**ADDENDUM NO. 3
TO THE
BIDDING REQUIREMENTS AND CONTRACT DOCUMENTS
FOR THE
DIV IV DRY WEATHER PUMP STATION AND FORCE MAIN REHABILITAITON**

OWNER: **City of Anderson**

ISSUED BY/ENGINEER: Egis Group
8320 Craig Street
Indianapolis, Indiana 46250

ISSUE DATE: January 8, 2026

DRY WEATHER PUMP STATION

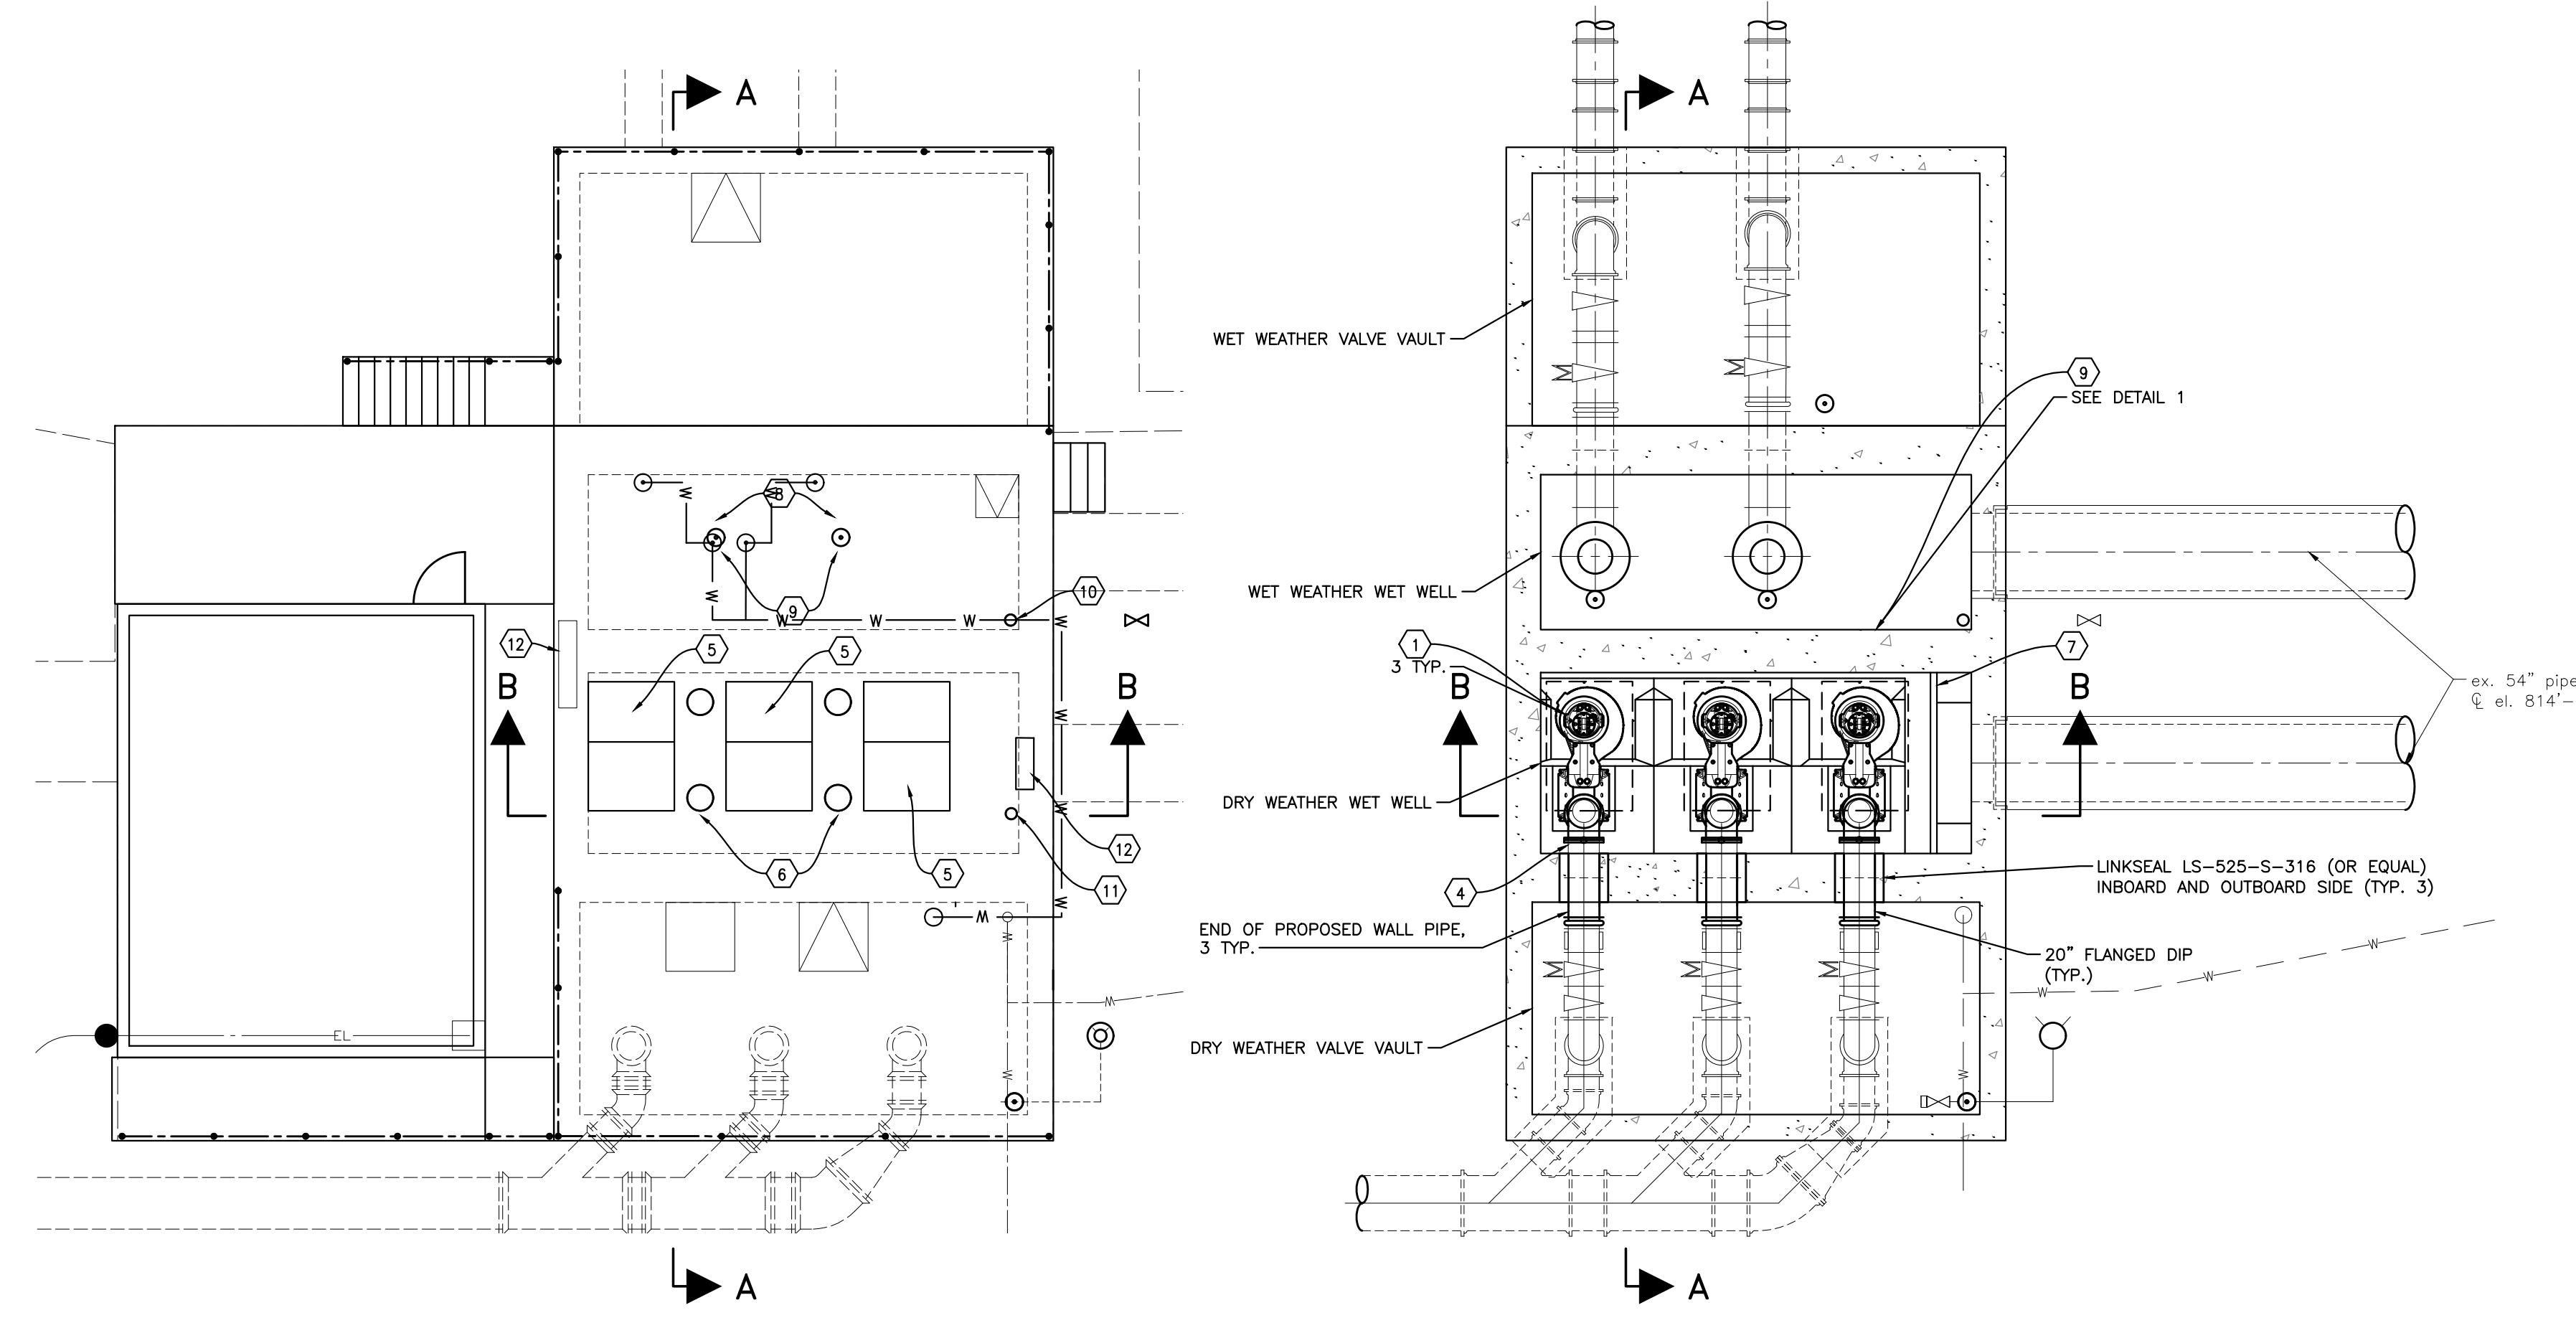
- A. Sheet C106 – Updated elevations have been added to Sheet C106.
- B. Sheet C107 – Updated elevations have been added to Sheet C107.
- C. Sheet C300 – Updated Trench Detail table.

E. Are dry-prime (vac-assisted) pumps an option? How deep below-grade is the water surface, and how deep overall is the wet-well? What is the minimum depth level allowed between grade and water surface?

Response: Specification Section 07721 only lists an acceptable manufacturer for roof scuttles/hatches under section 2.9.K. The following are acceptable manufacturers for all other hatches: Bilco, Halliday, EJ, and Flyght/Xylem. This information will also be added to Specification 07721 Section 2.5. All hatches must be able to meet the technical specifications and the physical opening requirements listed on drawing C107 Note 5.

Response: Diesel powered dry-prime pumps are acceptable for bypass pumping. Wet well top and bottom elevations are provided on the plan sheet C107. Please refer to the attached 2009 plan sheets of the screen structure for depth information, including maximum water surface information during wet weather. Bidders are encouraged to visit the site as well if unable to attend the advertised pre-bid meeting. Site visits must be pre-arranged with Engineer.

TRENCH DETAIL

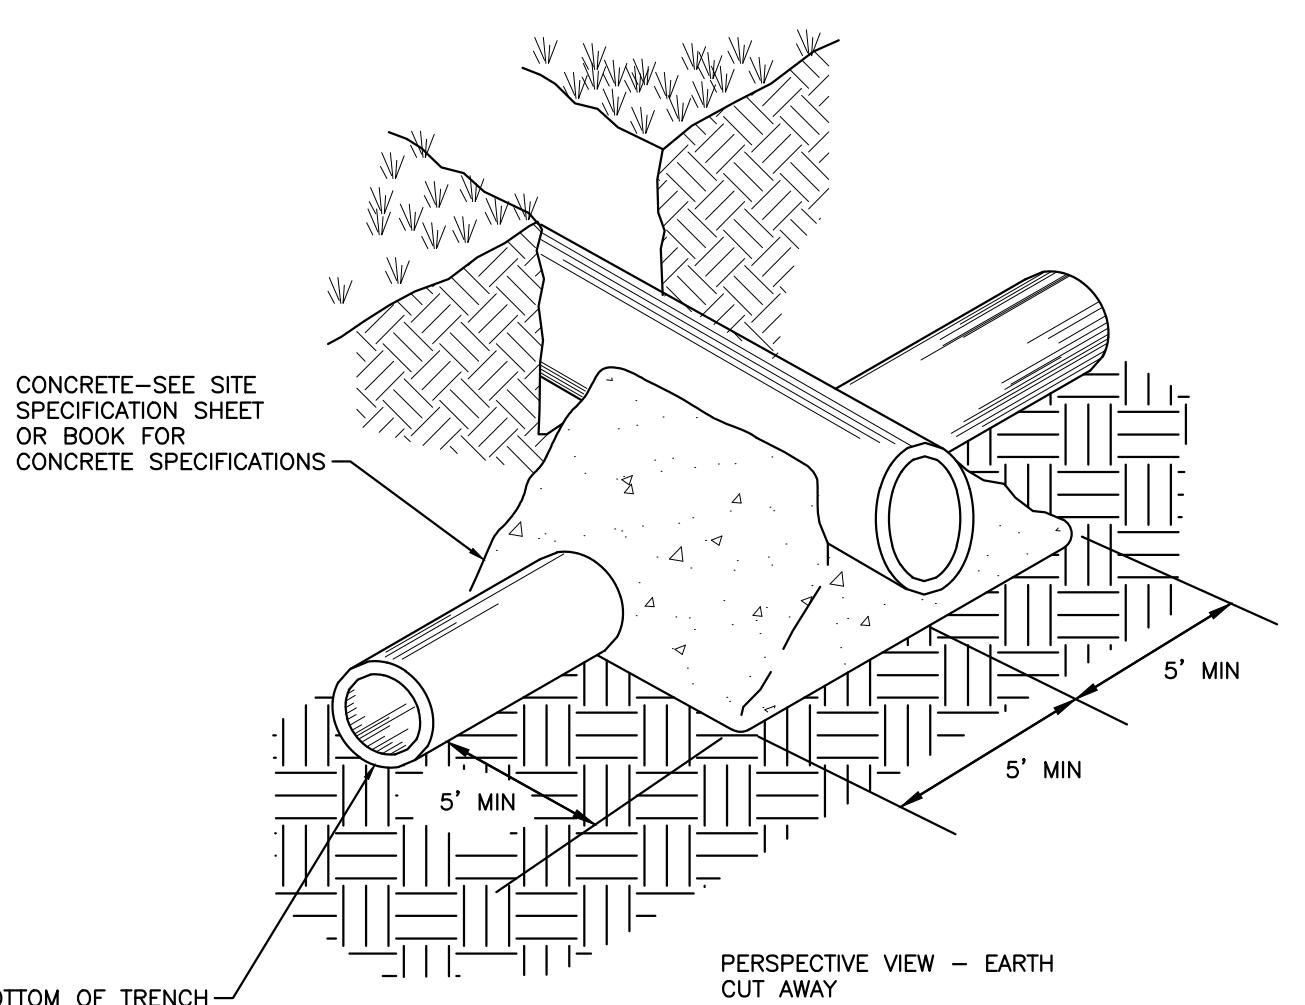
CC. Can the excavated material be placed back in the CIPP inversion pits after the connections are put back and bedded in engineered fill?

Response: Please refer to comments above, the attached the trench detail on sheet C300, and Specification 02300 for the definition of Satisfactory Soil. So long as the native soil meets the definition of in the specification and is not under or within 5-foot of pavement, it could potentially be utilized for final backfill.
